MARK	DATE	DESCRIPTIONS	BY	CH'D	CCO#
0	03/08/10	MEP INTEGRATION	JE	FW	110

CONTRACT CHANGE ORDER NO._____
SHEET _____ OF _____

DETAILS
SCADA REMOTE TERMINAL UNIT SYSTEM
RTU #14E WIRING DIAGRAM
NO SCALE

E-934

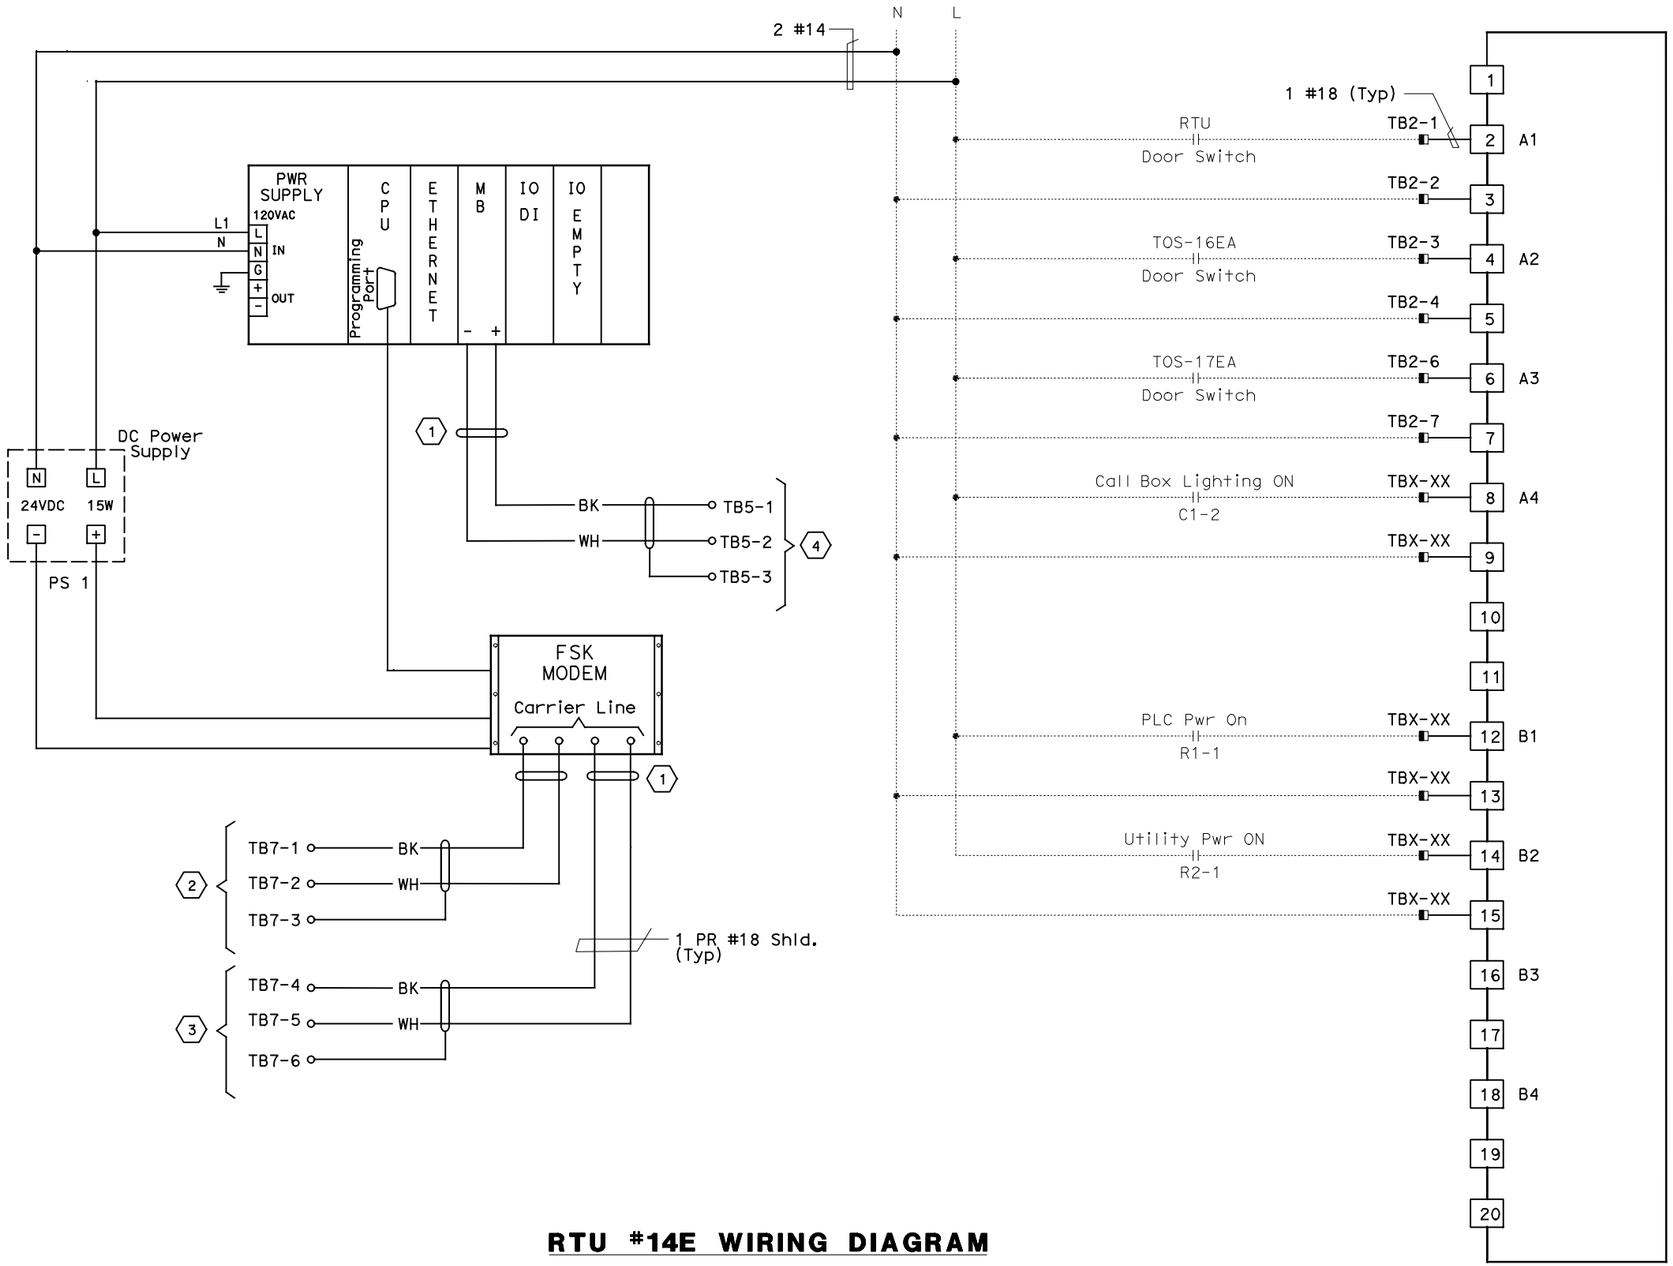
RTU #14E WIRING DIAGRAM

1. Contractor shall install input card. See sheet E-931 for location.
2. Contractor shall wire connection shown by bold lines.

(1) Contractor to tape shield. This circuit is not to be grounded at this end.

(2) Pair 7 of 50 pair SCADA cable.

(3) Pair 8 of 50 pair SCADA cable.

(4) To Call Box Communications cable RS-485.
